PR/0376/22

Record of Executive Business and Chief Executive's Order

Reg. Reference: SD21A/0321 **Application Date:** 22-Nov-2021
Submission Type: Additional Information **Registration Date:** 25-Feb-2022

Proposed Development: Construction of 2 storey, detached house (single family dwelling on a corner/side garden site); new boundary walls to replace existing with 2 new pedestrian entrance gateways; associated site works, landscaping and connections to public services.

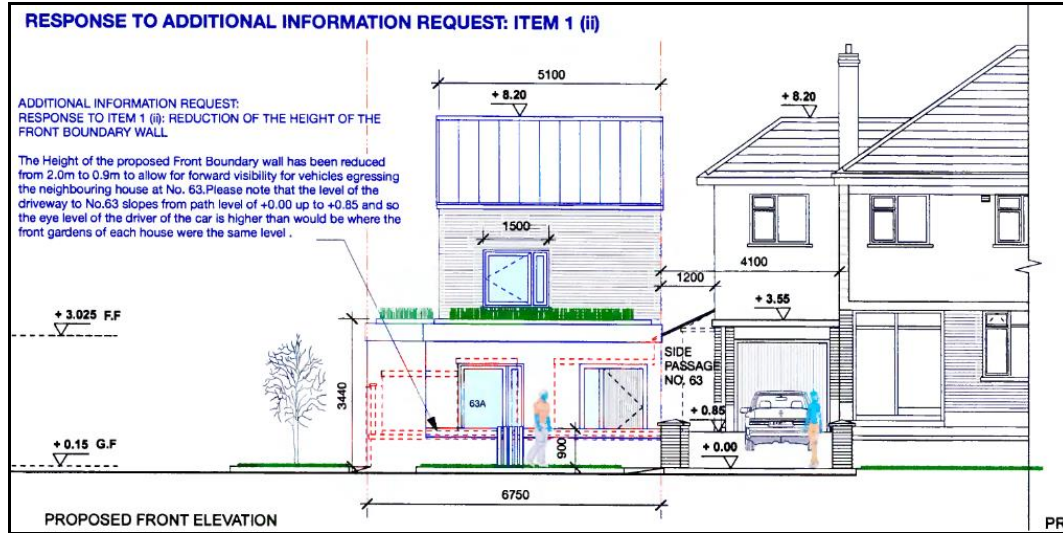
*The applicant has made a case for having no on-curtilage parking and this was considered by the Roads Department. However, with reference to **Section 11.4.2** of the **SDCC County Development Plan 2016-2022**, in order to be considered for car free housing, the site must “have convenient access to high frequency public transport services and / or are located within a town or village centre” This site is not in a town or village centre so access to high frequency public transport was investigated. It was found that;*

- *Section 11.4.2 of the SDCC County Development Plan 2016-2022 states that in order to be considered for lower parking rates in Zone 2 a site must be **within 400m of a high quality bus service.***
- *Section 11.4.2 of the SDCC County Development Plan 2016-2022 states that A high frequency route is where buses operate with a minimum **10 minute frequency at peak times and a 20 minute off-peak frequency.***
- ***250m** from the proposed site is Willbrook Road Stop 2946 which is only serviced by the **No 61 bus** which stops approx. every **1hr.***
- ***550m** from the proposed site is Willbrook Road, Stop 1330 on Grange Road which would be considered a high quality route with numerous bus services running every **10 mins** approx.*
- *The nearest high quality bus service is therefore beyond the threshold of 400m and so the site cannot be considered for car-free housing.*

The applicant has also submitted 2 possible options for locations of off-curtilage parking but they are in areas outside the ownership of the applicant so cannot be considered as they would set an undesirable precedent for further similar parking arrangements in the area.
